INDIANA DEPARTMENT OF TRANSPORTATION
Driving Indiana's Economic Growth

APPROVED MINUTES

July 21, 2011 Standards Committee Meeting

RE: Minutes from the July 21, 2011 Standards Committee Meeting

805-TSCS-01 TRAFFIC SIGNAL CANTILEVER STRUCTURE SIGNAL ARM DIMENSIONS & DETAILS

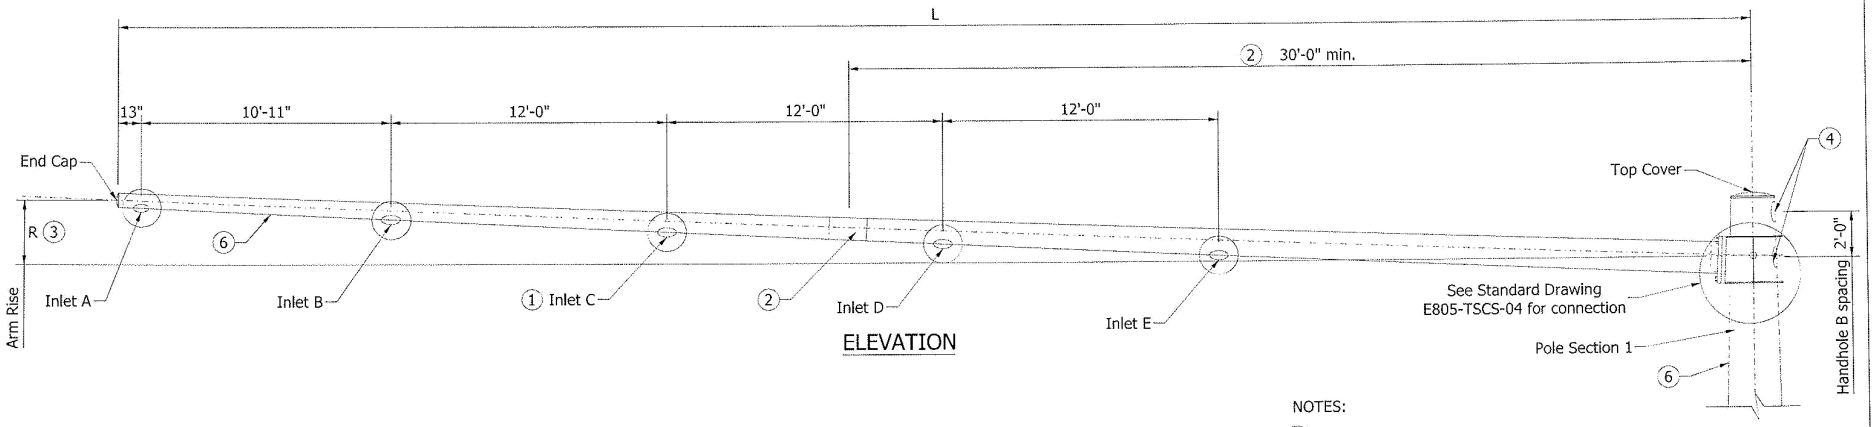
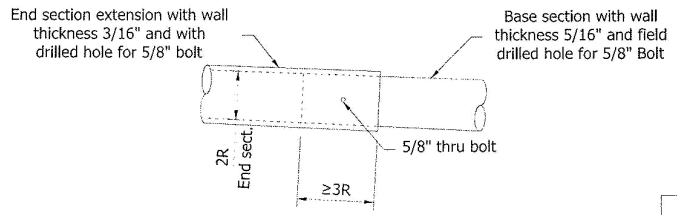
PROBLEM(S) ENCOUNTERED: Existing Signal Mast Arm standard drawings doesn't meet the latest AASHTO code requirements.

PROPOSED SOLUTION: New Signal Cantilever Structures and foundation standard drawings were developed meeting the latest AASHTO code (2009 fifth edition) requirements.

Mr. Miller addressed the standard drawings and asked if these drawings are new or if they had been revised, since there are no revisions or mark-ups shown on the proposed drawings. Mr. Hanza confirmed that these drawings are new. Mr. Miller asked if this needs to be passed today, or if we can wait until we get the whole proposal the way we want it. Mr. Patel recommended approving the drawings and reworking the

Mr. Zafar revised his motion to withdraw this item at this time.
Mr. Patel clarified that the drawings are okay but the spec language needs to be revised. This item was withdrawn.
